Title & Document Type: 8405A Vector Voltmeter Operating and Service Manual

Manual Part Number: 08405-90024

Revision Date: May 1971

VECTOR VOLTMETER 8405A

Figure 7-11(b). Schematic Diagram, Phase Meter (CHANGE 17)

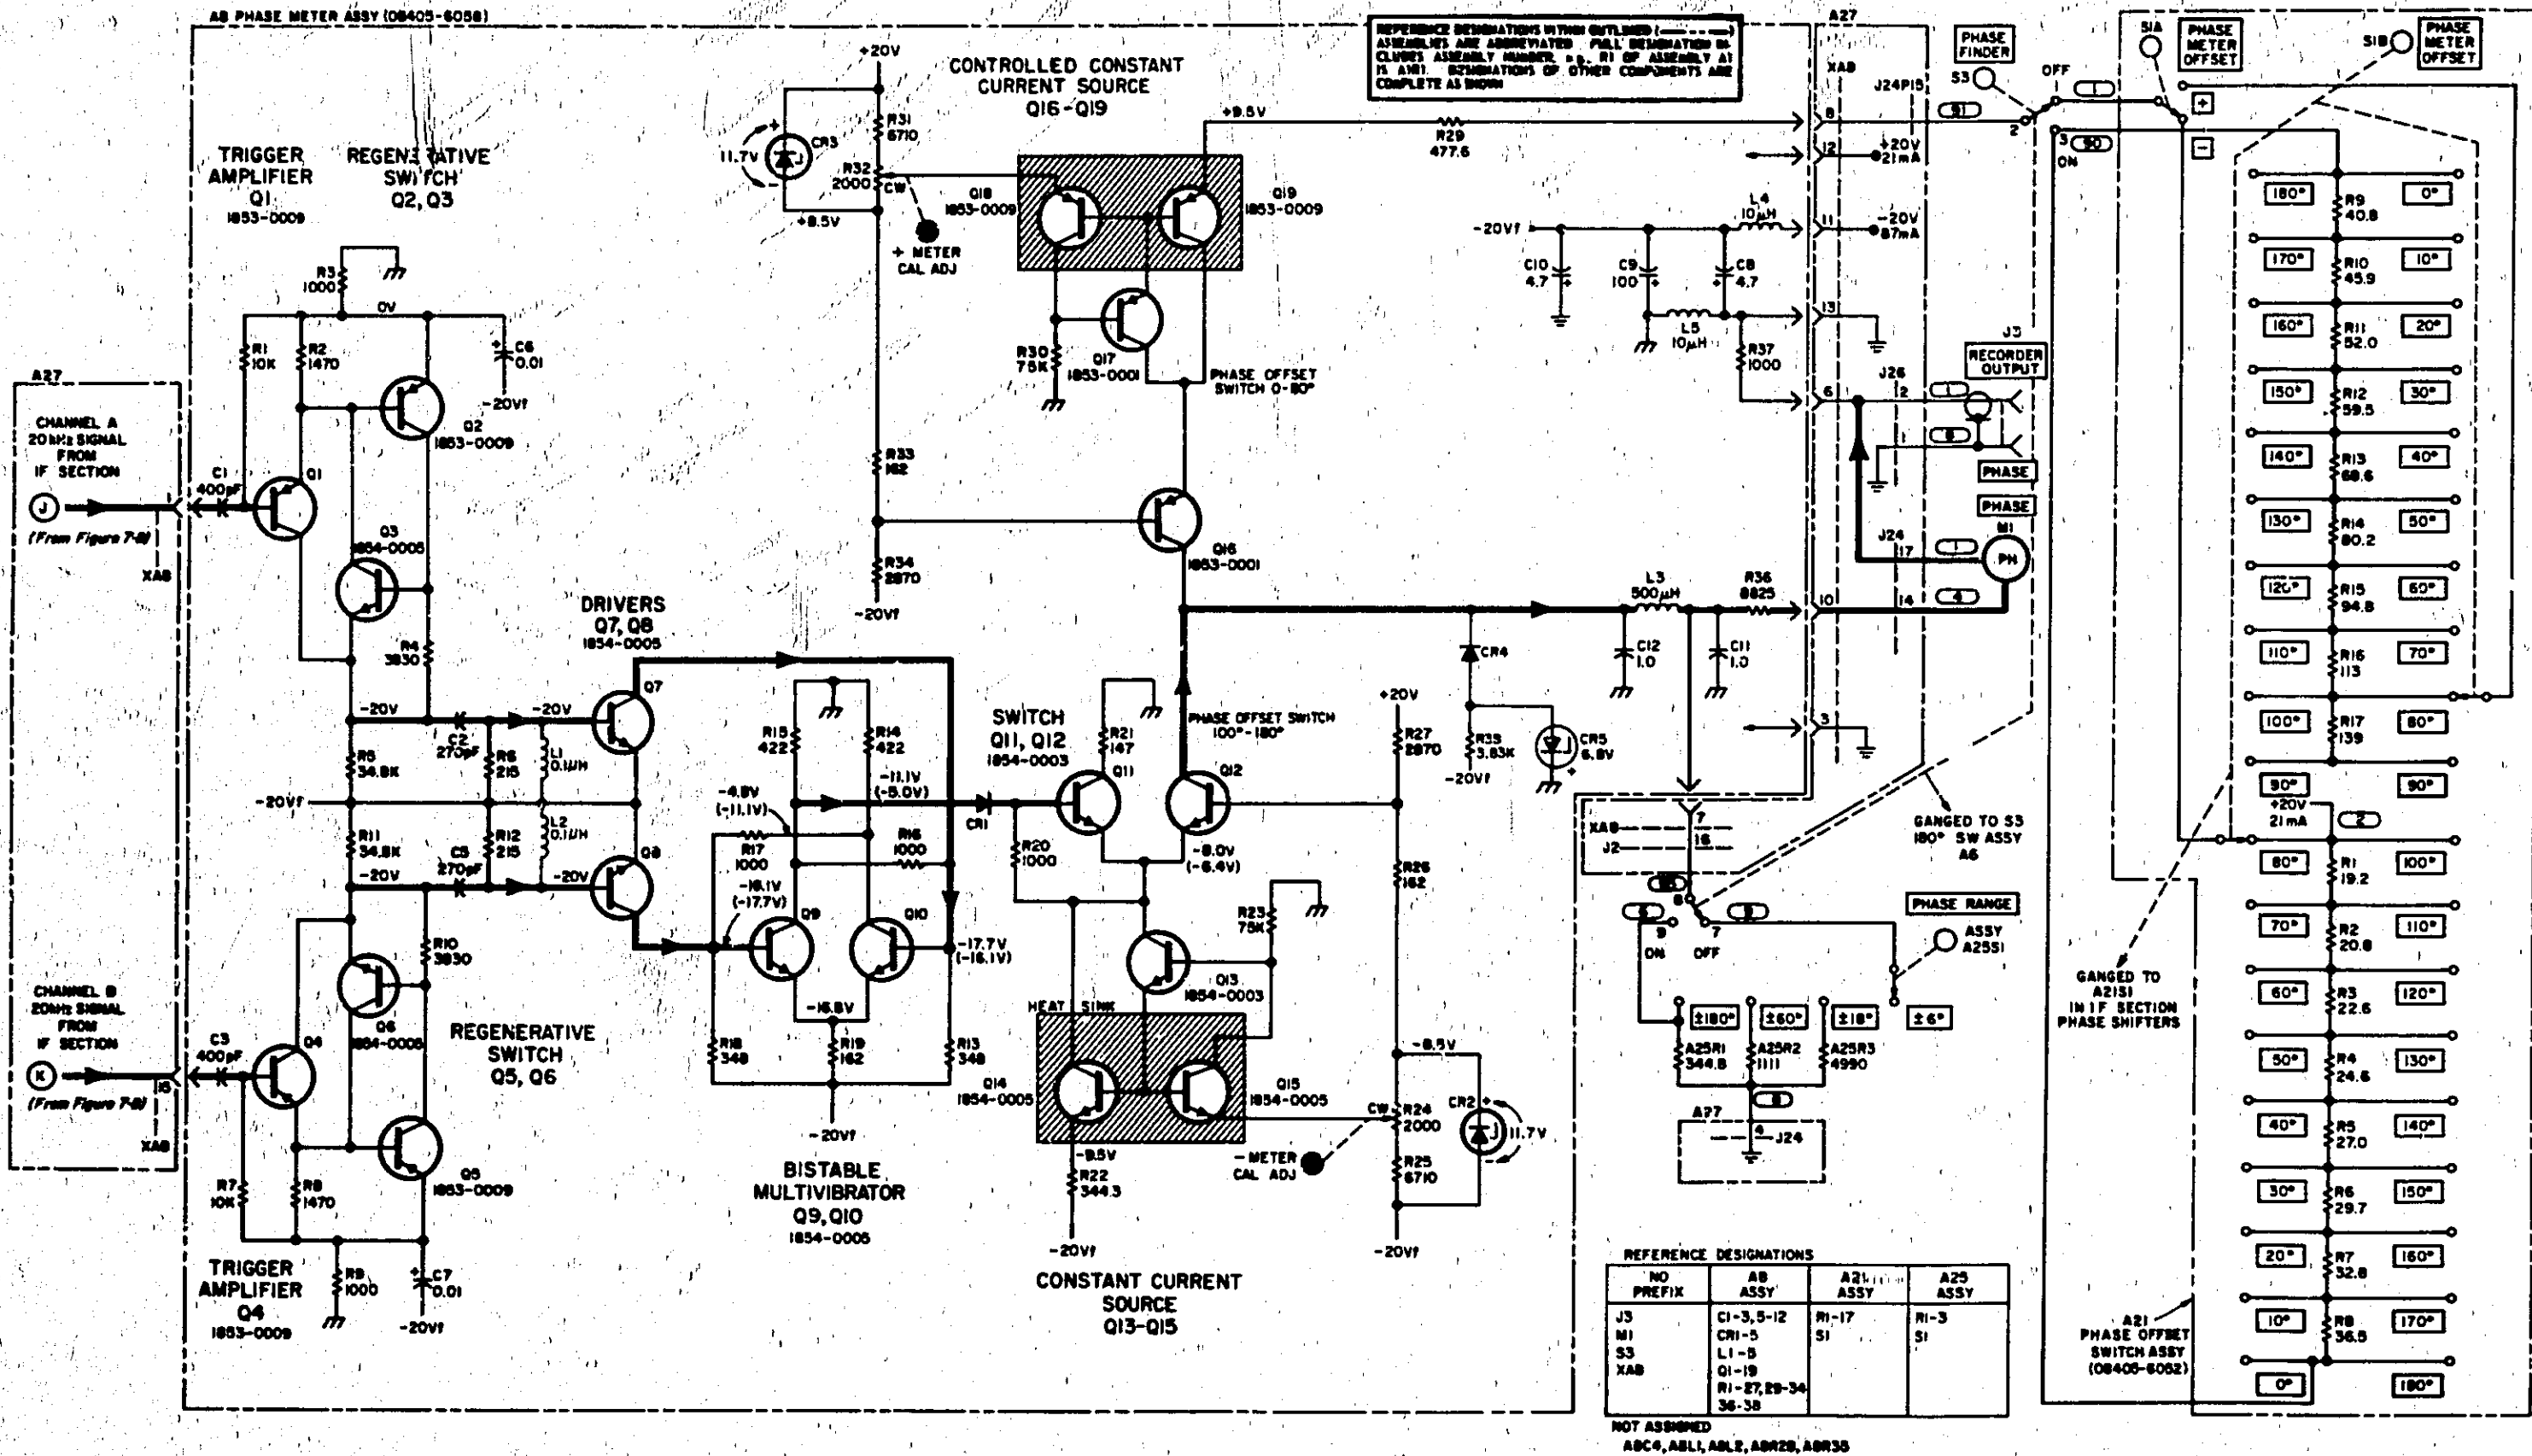
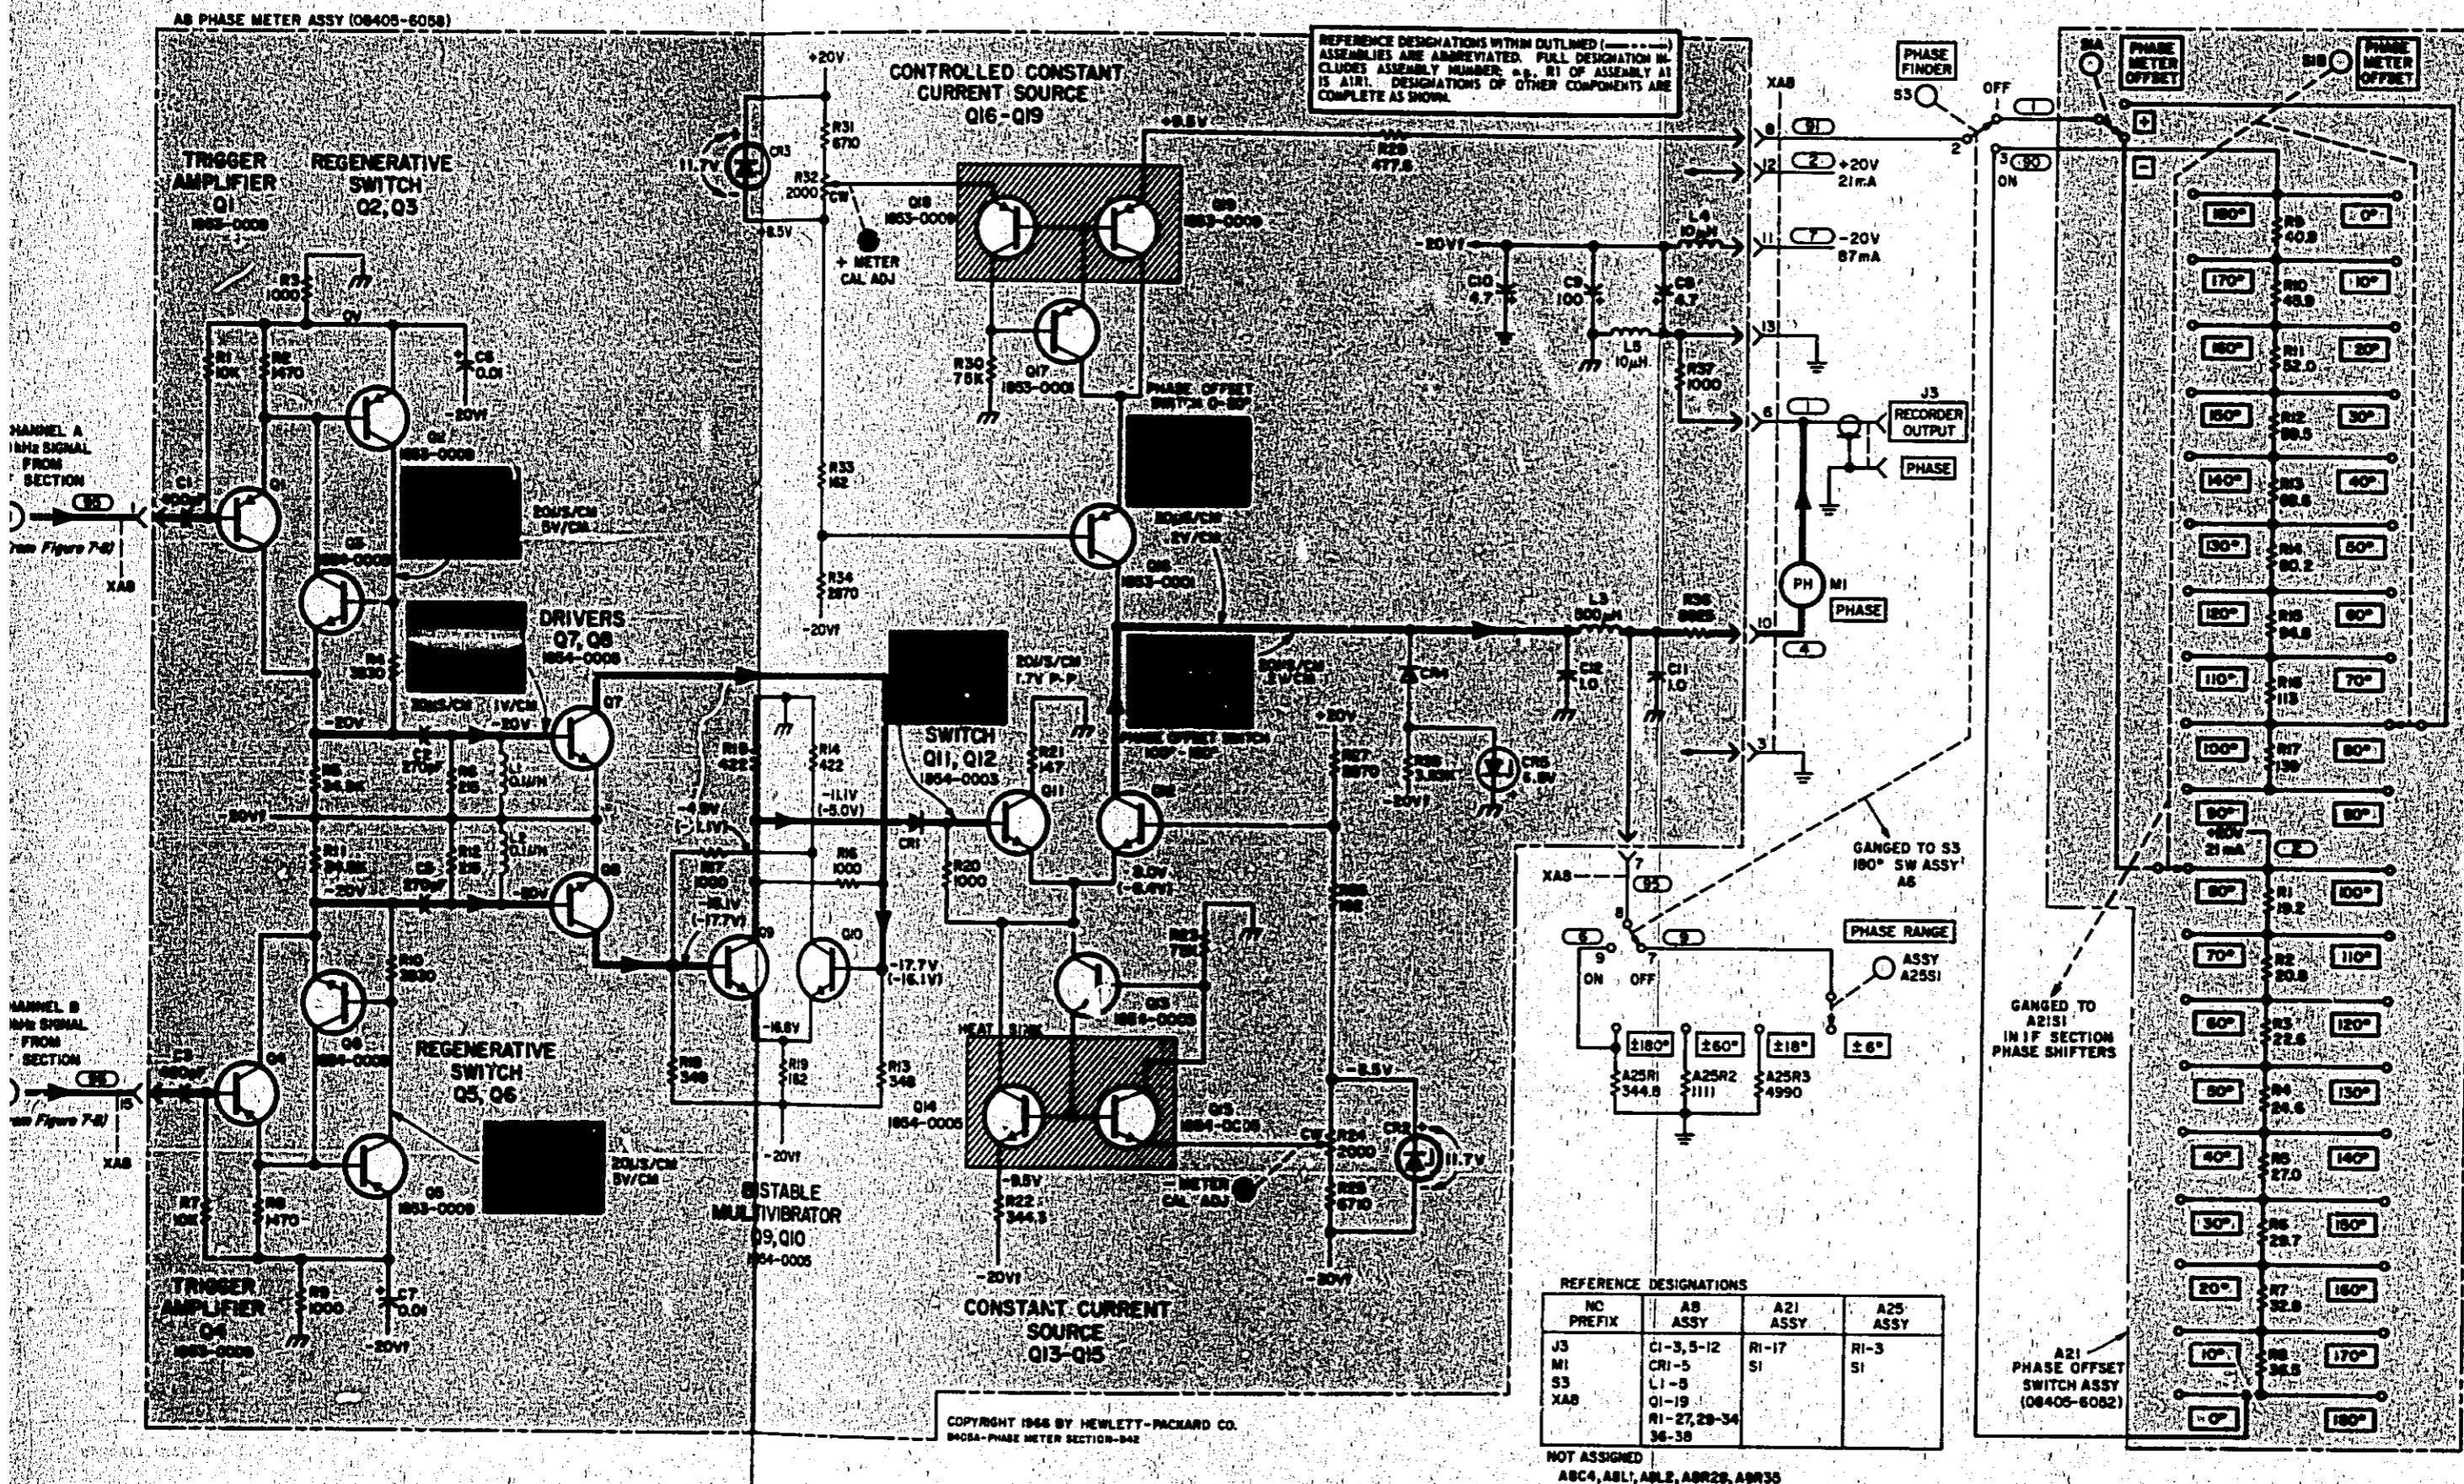
Figure 7-11(b):

Change Figure 7-11(b) of Change 17. In the lower left corner of the replacement page, the A21 Phase Offset Switch Assy is identified as part number 08405-6052. Replace the part number with this note: See Table 6-1 for current assembly number.
